# ARCHITECT'S SUPPLEMENTAL INSTRUCTION NO. 4

**DATE:** November 07, 2023 **PROJECT NO: 230117**

RE: Streets of West Pryor - Lot 5 Core & Shell

SHEET NUMBER M-101

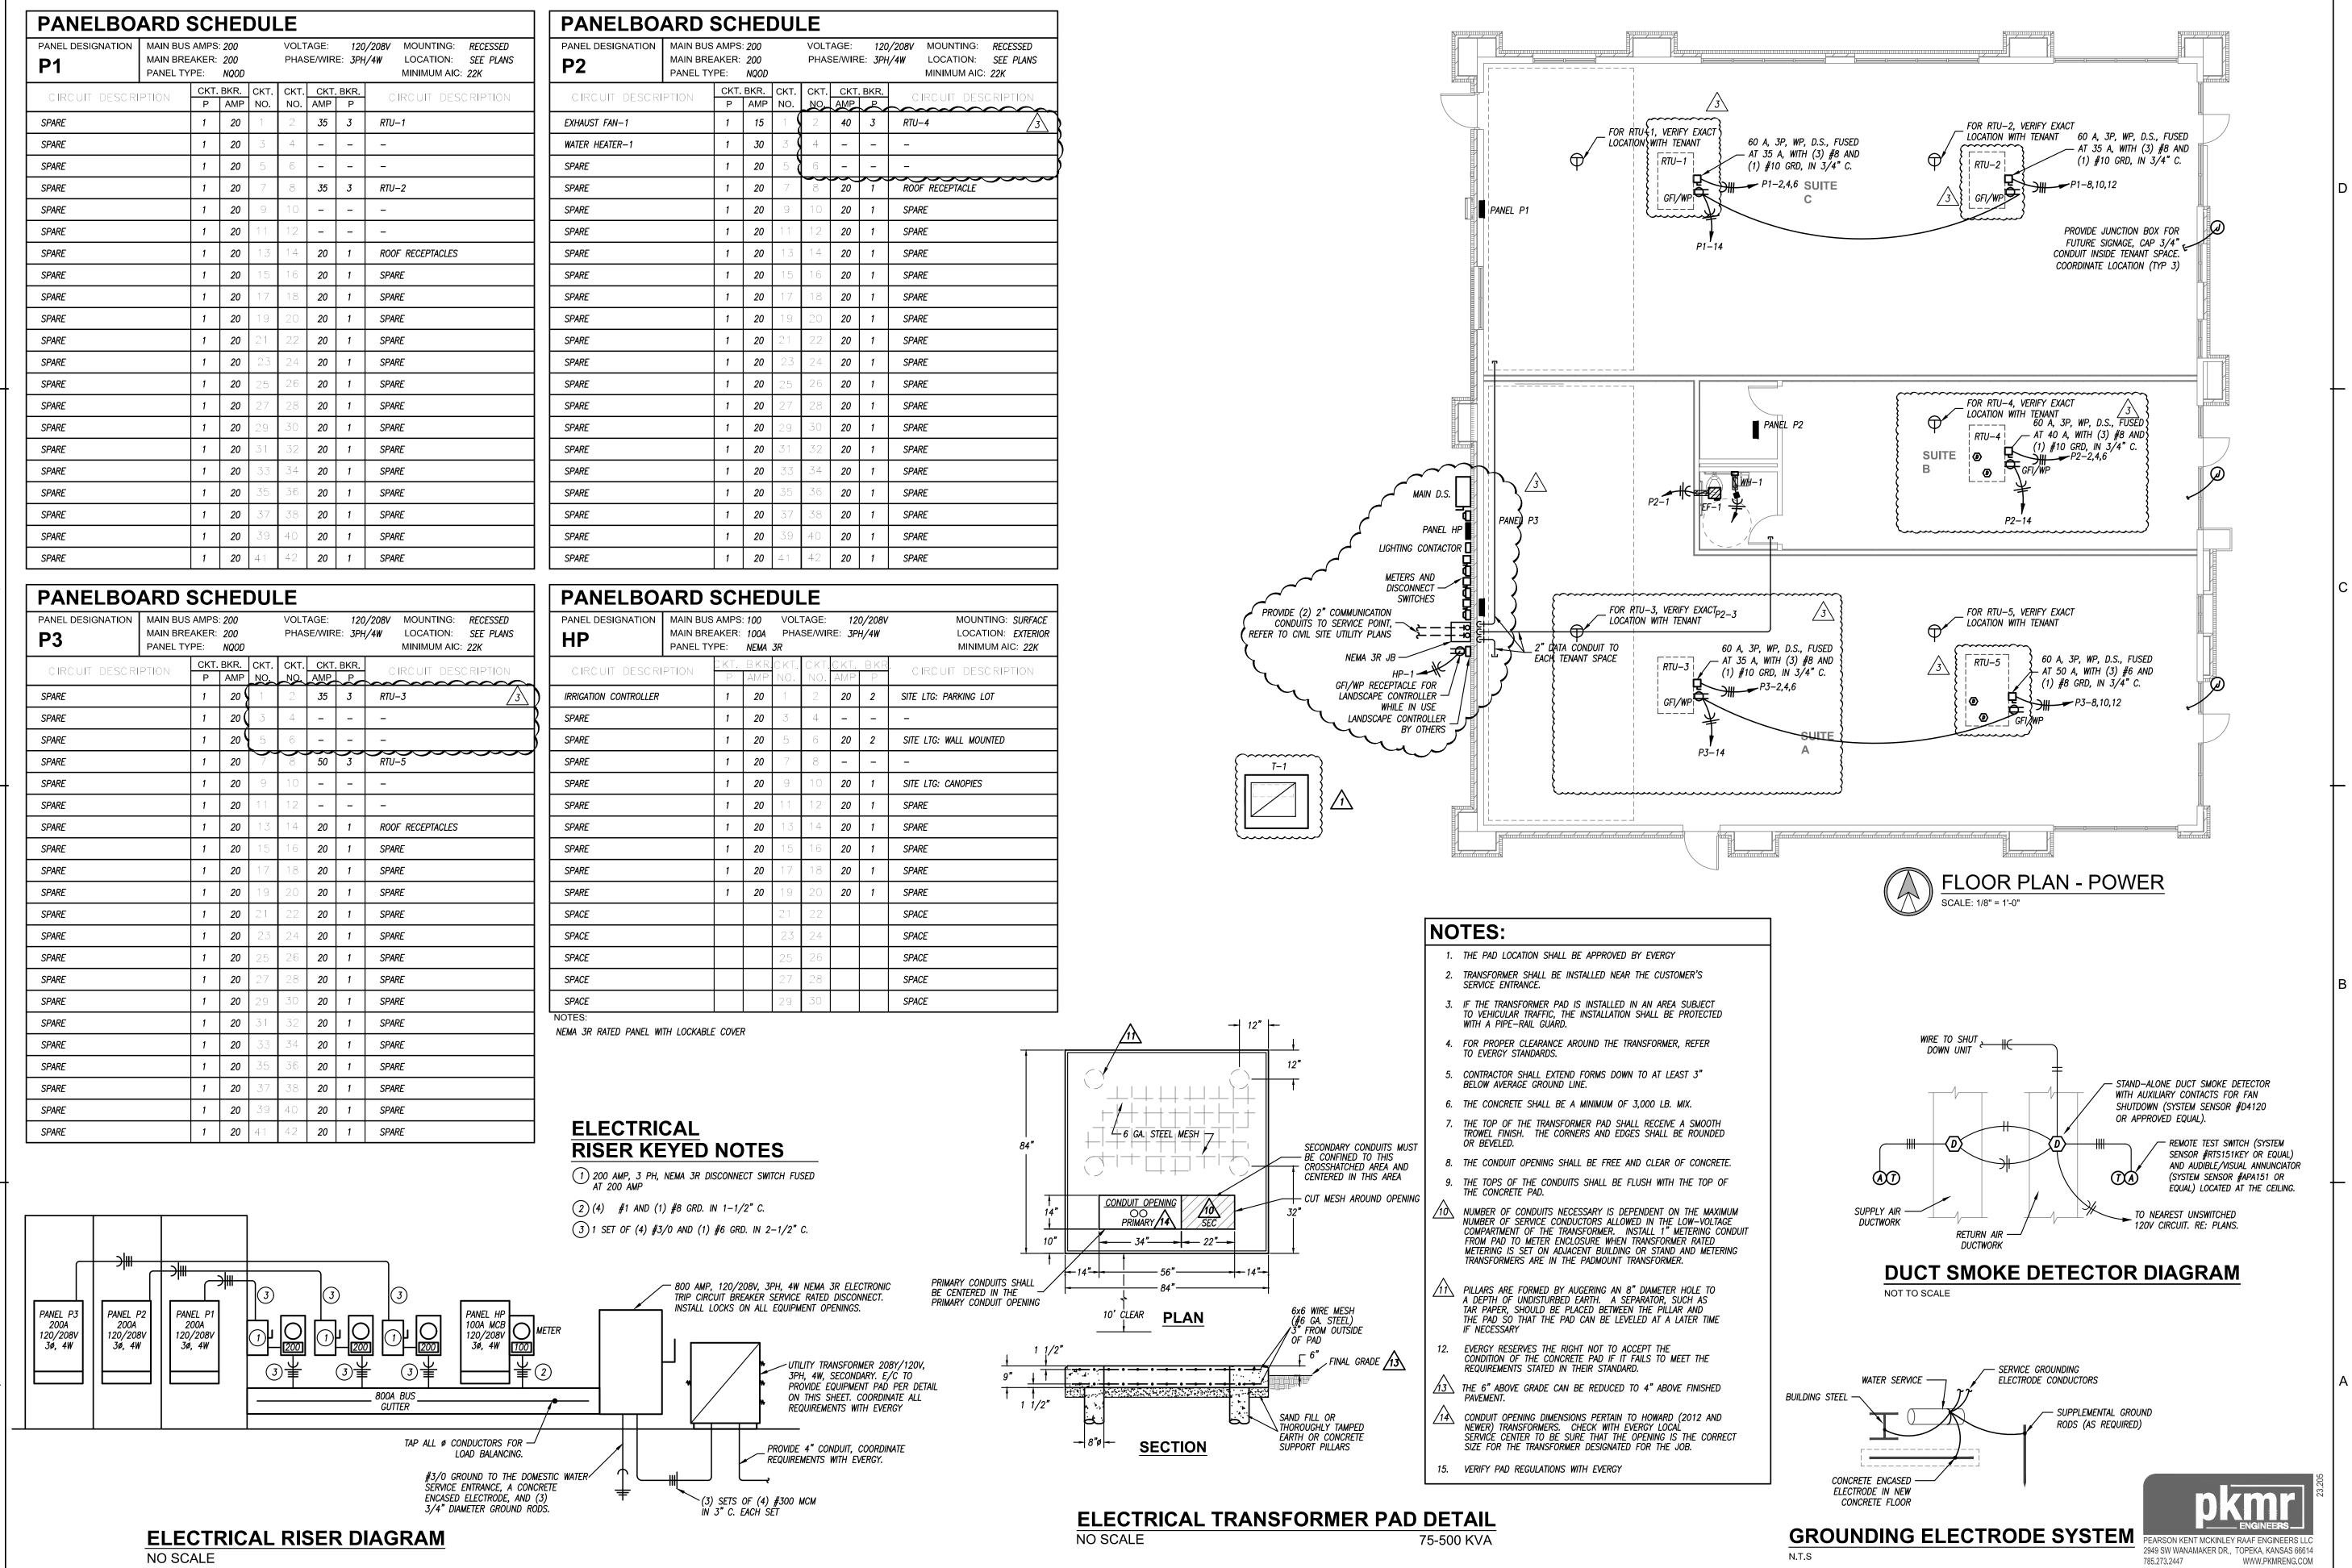
- MEP-1 Sheet ME-201 Updates to Light Fixture Schedule to show "C" fixtures on exterior. MEP-1.A Movement of Light Poles.
- MEP-2 Sheet ME-202 Updated placement of exterior utilities
- MEP-3 Sheet M-101 Swapping the respective placement of RTU 3 and RTU 4 for each other. MEP-3.A Rotation of RTU units
- MEP-4 Sheet M-201 Rotation of RTU units
- MEP-5 Sheet E-101 Swapping the respective placement of RTU 3 and RTU 4 for each other.
